Welding Procedure Specification No. 01128B101 Date 4/28/77  
Revisions 4 6/29/79

PQR No.	0112BB101	Rev.	4
WPS No.	0112BB101		4

CHANGE NOTICE  
PROCEDURE QUALIFICATION RECORD  
QUALIFYING WELDING PROCEDURE SPECIFICATION

Sketch/Comments

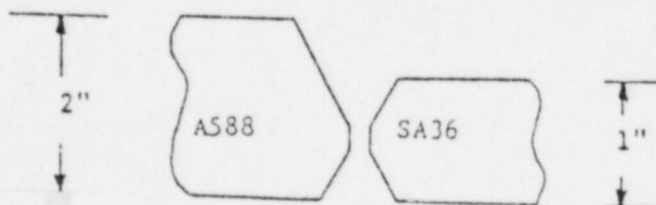
PQR	4	Changed "thickness range qualified" to "deposited weld metal thickness". Added joint dimension information, tungsten size and type, peening and backgouging. Added material specifications to joint detail.

Bevel:  $37\ 1/2^\circ \pm 2\ 1/2^\circ$  Land:  $3/32'' + 0 - 1/32''$  Gap:  $1/8'' + 0 - 1/32''$

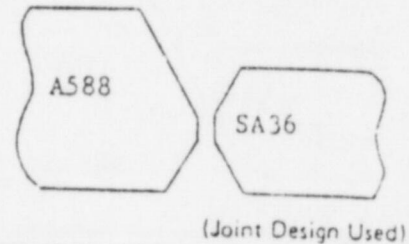
PQR	1	Corrected typographical error on tensile #2 ultimate stress from 74,497 to 71,497.
PQR	2	Corrected travel speed from 10-18 IPM to 2.5-5.5 IPM.
PQR	3	Retyped on new form. Added the following information: WPS number, joint sketch & dimensions, O.D. range qualified, thickness range qualified per process, electrode size, electrode-flux class., consumable insert, welding progression, PWHT type & time range, purge flow rate, bead width, orifice or gas cup size. Changed "passes/side" to "multi or single layer", "number of arcs" to "multiple or single electrode". Deleted reference to "atmosphere trade name", "backing", and "who by virtue of these tests meets welder performance requirements". Changed filler trade name to "N/A". Information previously indicated under "oscillation" is entered under "bead width" and added "N/A" under oscillation.
WPS	4	Deleted reference to supporting PQR and added peening and preheat maintenance. Added material specifications to joint detail.
